**TOWN OF NEWBURGH
PLANNING BOARD
TECHNICAL REVIEW COMMENTS**

PROJECT NAME: DARRIGO SOLAR
PROJECT NO.: 19-24
PROJECT LOCATION: SECTION 86, BLOCK 1, LOT 96
REVIEW DATE: 1 MARCH 2024
MEETING DATE: 7 MARCH 2024
PROJECT REPRESENTATIVE: ARDEN CONSULTING

Subject: Darrigo Solar Farm Landscape Plan Comment Response Memo
Comments Received by Email (Town Project Number 2019-14)

AMENDED 5 MW AC SOLAR FARM SITE PLAN FOR DARRIGO 84 LAKESIDE AVENUE TOWN OF NEWBURGH – ORANGE COUNTY, N.Y.

L-502
SHEET 4 OF 4

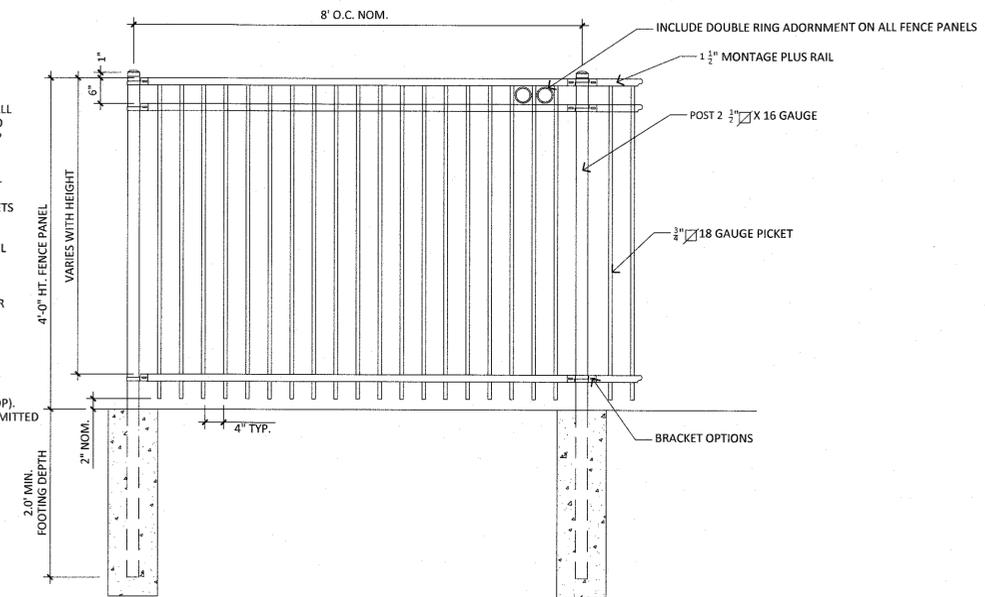
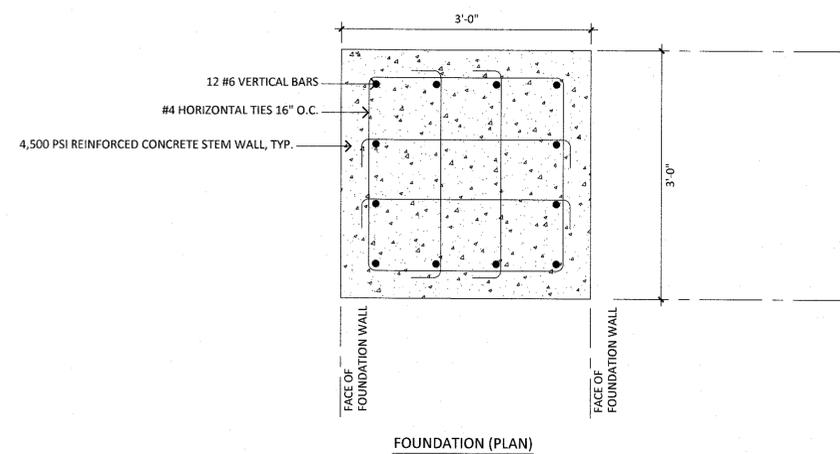
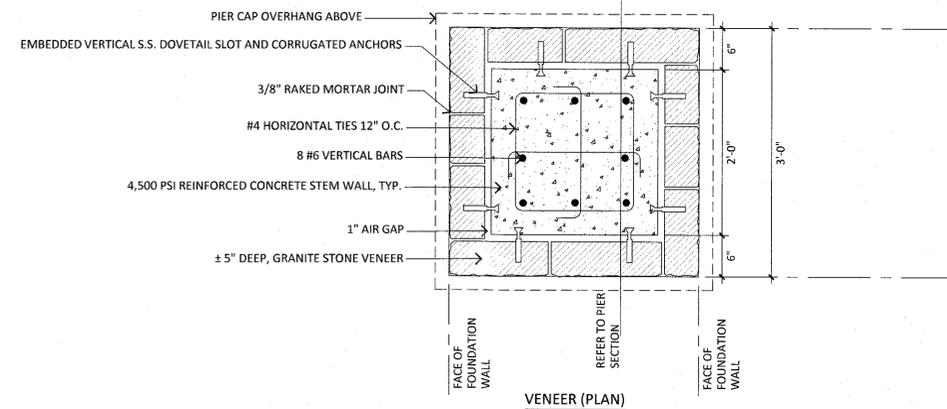
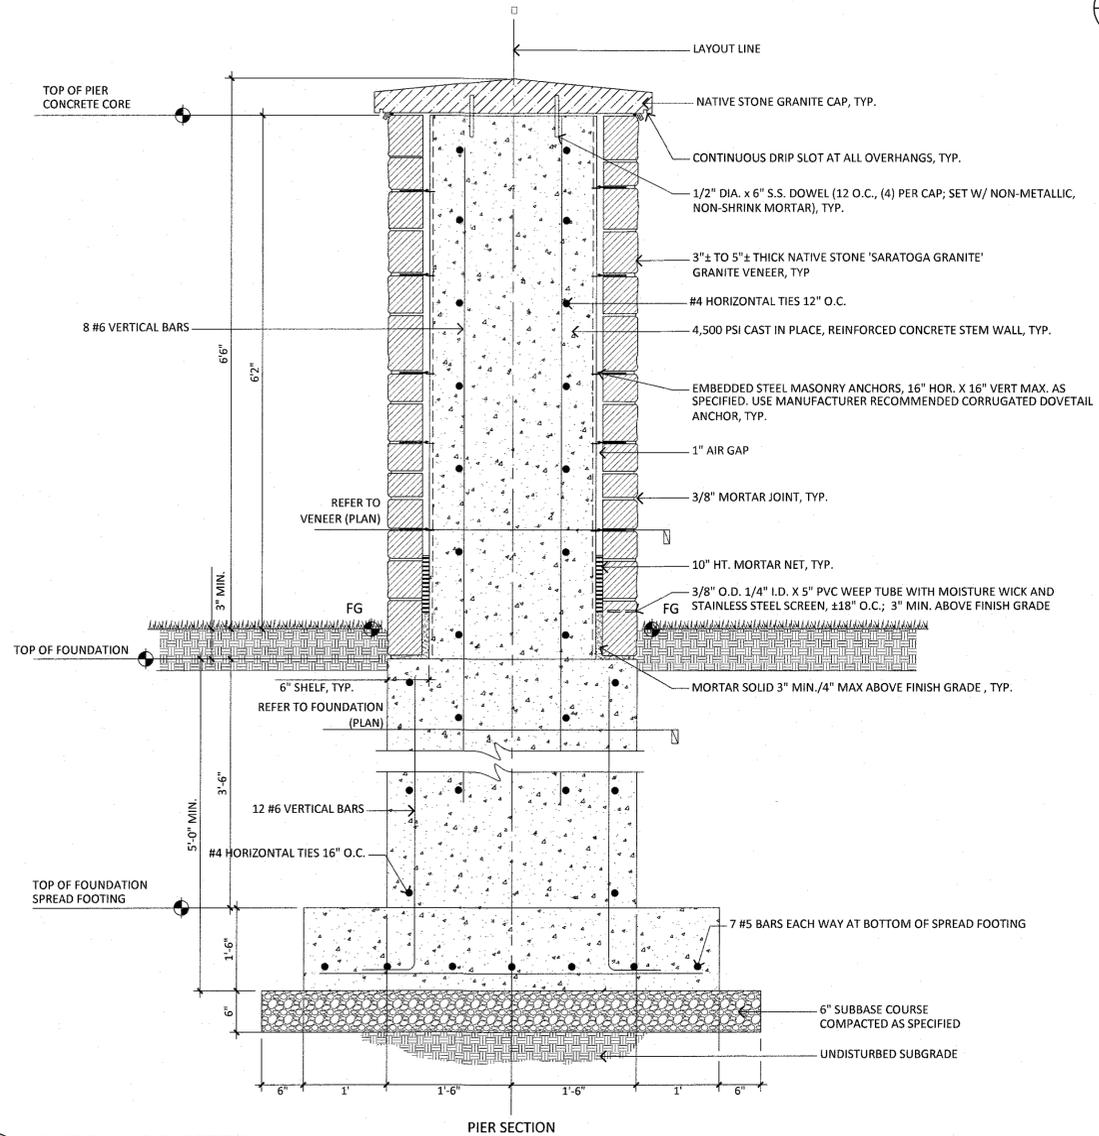
5. No fence details were included. Please include a detail for the proposed fencing at the lakeside road entrance. Fence and gate details have been added on Sheet L-502.

5. Please include a detail for the proposed fencing at the Lakeside road entrance. This fence will be highly visible from the road and it should be aesthetically pleasing.
